Hinxton Parish Council (HPC)

Proposal: Submission of details required by condition 24 (Site Wide Lighting Strategy) of outline planning permission S/4329/18/OL

Site address: Wellcome Trust Genome Campus Cambridge Road Hinxton Saffron Walden

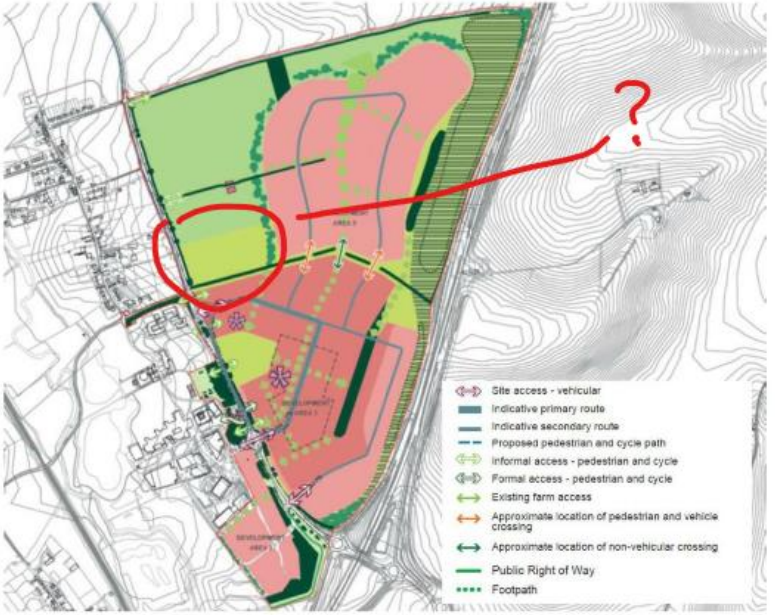
2.		<p>The area within DA3 adjacent to Hinxton Village is particularly sensitive, because it preserves an agricultural “buffer zone” against the residential development, shown marked red below.</p> 
	Section 1, Project Description
